Recall Campaign Bulletin

Campaign No. 2022030028, April 2022

SUBJECT: **Model S-Class (223 platform)**
Model Year 2022

Check and Replace Rear Axle Carrier

Figure 2

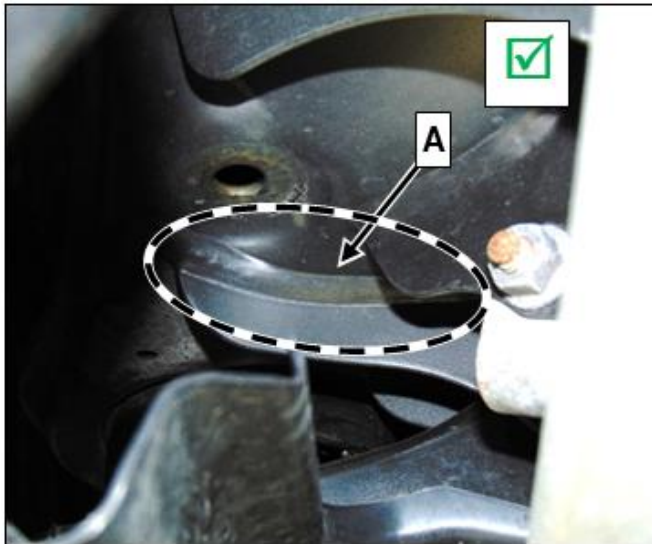
1. Lift vehicle.
2. Check weld seam (A, figure 2) of thrust arm connection to rear axle carrier **on both sides**.

-  The connection must be end-to-end welded at the rear axle carrier!
-  Area to be checked must be well illuminated!

- a. Weld seam (A) **not** OK: Perform **work procedure**.
- b. Weld seam (A) OK: **Perform step 3 and End measure**.

1. Remove rear axle.
i For basic data, see **AR35.10-P-0010S**.
2. Replace rear axle carrier (A) (figure 1 and 2).
